## Summary Report VA Medical Center

VA Medical Center Tower Liquid Engineering Corporation Job #55092

Tank Name:	Tower	Tank Type:	Elevated
City:	Sioux Falls	Tank Capacity:	100,000
State:	SD	Type of Construction:	<b>Riveted Steel</b>
Year Built:	Not Provided		
Inspected By:	LEC Dive Team 14		
Inspection Date:	October 5, 2020

# 7.) Overflow

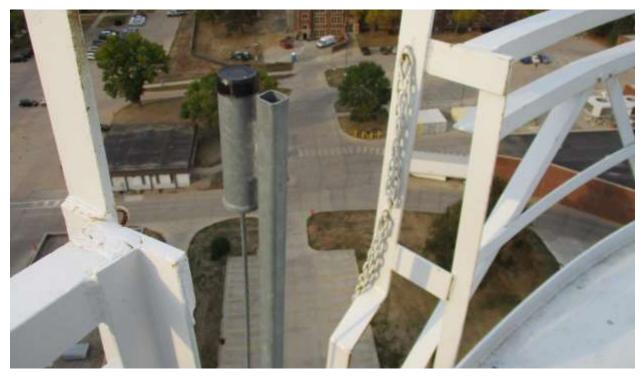
- We recommend installing a new screen on the existing overflow pipe elbow. (See photo 7)
- We recommend adjusting the windage rods, as needed, to withstand 100 mph winds blowing from any direction to adhere with AWWA D100-11; 3.1.4 Wind load. This work should be performed on an emergency basis. (See photo 9)

# 13.) Lack of Roof Handrails

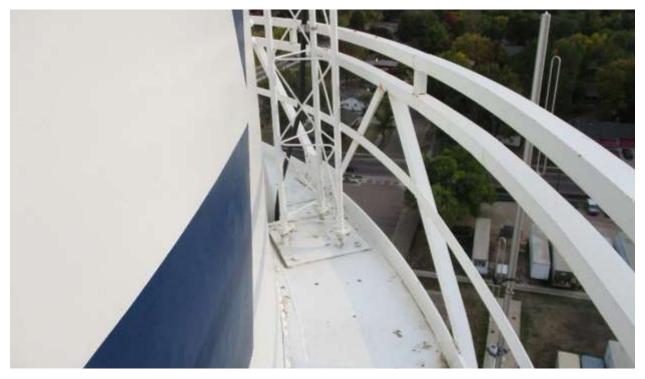
- OSHA 1910.28(b)(1)(i) states, "...the employer must ensure that each employee on a walking-working surface with an unprotected side or edge that is 4 feet (1.2 m) or more above a lower level is protected from falling by one or more of the following: 1910.28(b)(1)(i)(A) Guardrail systems." OSHA 1910.29(b)(1) states, "The top edge height of top rails, or equivalent guardrail system members, are 42 inches (107 cm), plus or minus 3 inches (8 cm), above the walking-working surface." OSHA 1910.29(b)(2)(i) states, "Midrails are installed at a height midway between the top edge of the guardrail system and the walking-working surface;..." OSHA 1910.29(k)(1) states, "The employers must ensure toeboards used for falling object protection:..." We recommend installing an OSHA compliant 42" high handrail system around the circumference of the tank roof, complete with an intermediate rail, a toeboard, and a swing gate at the junction of the shell-to-knuckle roof access ladder and tank roof. (See photo 13)
